**PROJECT NO. 38-CW-1(SG)**  
**LAUDERDALE COUNTY BID NO. 3843**  
**SITE GRADING AT THE 1-20/59 INDUSTRIAL PARK**  
**LAUDERDALE COUNTY**

**ADDENDUM NO. 4**

DATE: January 4, 2019

**TRAFFIC CONTROL PLAN**  
120-59 INDUSTRIAL PARK  
LAUDERDALE COUNTY, MERIDIAN, MS

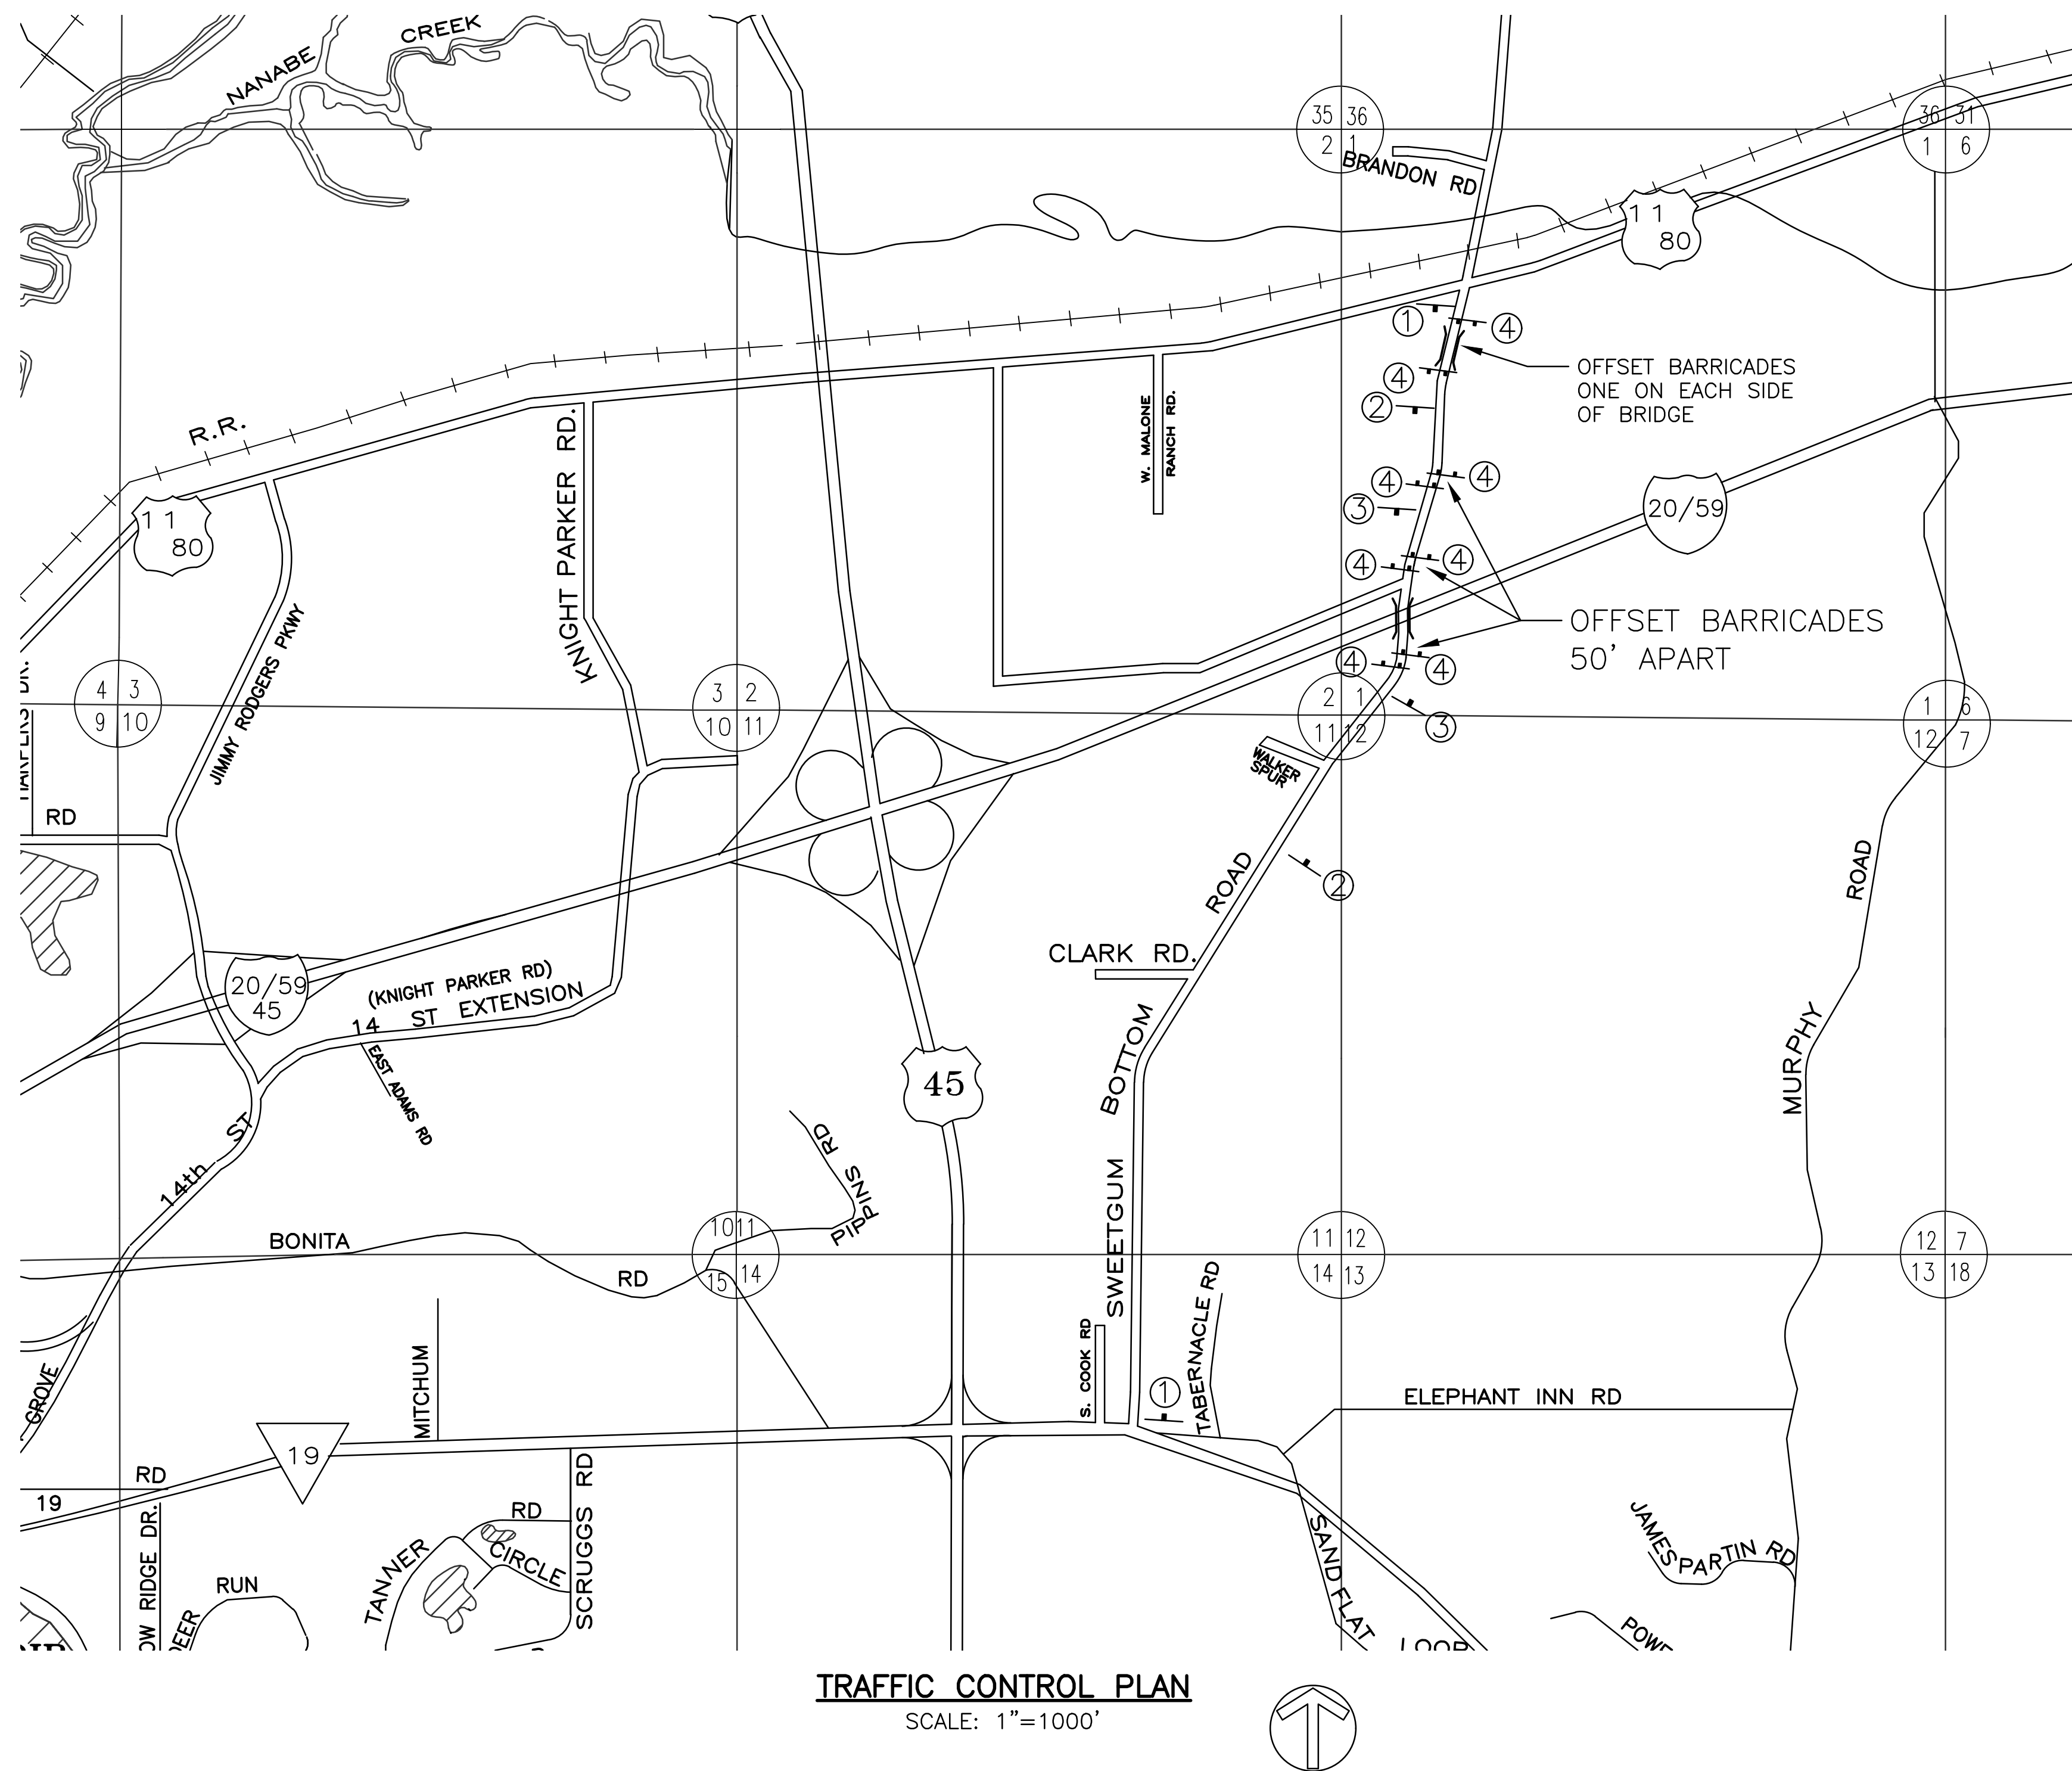
Sweet Gum Bottom Road, from North of I-20/59 to Highway 11/80, has been closed by city ordinance. However, the closure does not become effective until an alternate access is provided. The alternate access will extend adjacent to and parallel to I-29/59 from the existing Sweet Gum Bottom Road near the elevated water storage tank west, south of the existing NFI Distribution Center, to Handy Boulevard. For bidding purposes and, based upon current city plans, the detour road is to be completed no later than April 15, 2019. At that time, the roadway can be permanently closed.

It is possible the successful bidder may be able to work on either side of Sweet Gum Bottom Road and not have to cross the roadway from the time the contract begins until the roadway is formally closed. However, should construction traffic be crossing the roadway, traffic control devices need to be installed in accordance with the attached traffic control plan, Sheet C6.3. Flagmen shall be provided when equipment is crossing the roadway to minimize conflict between construction and public traffic.
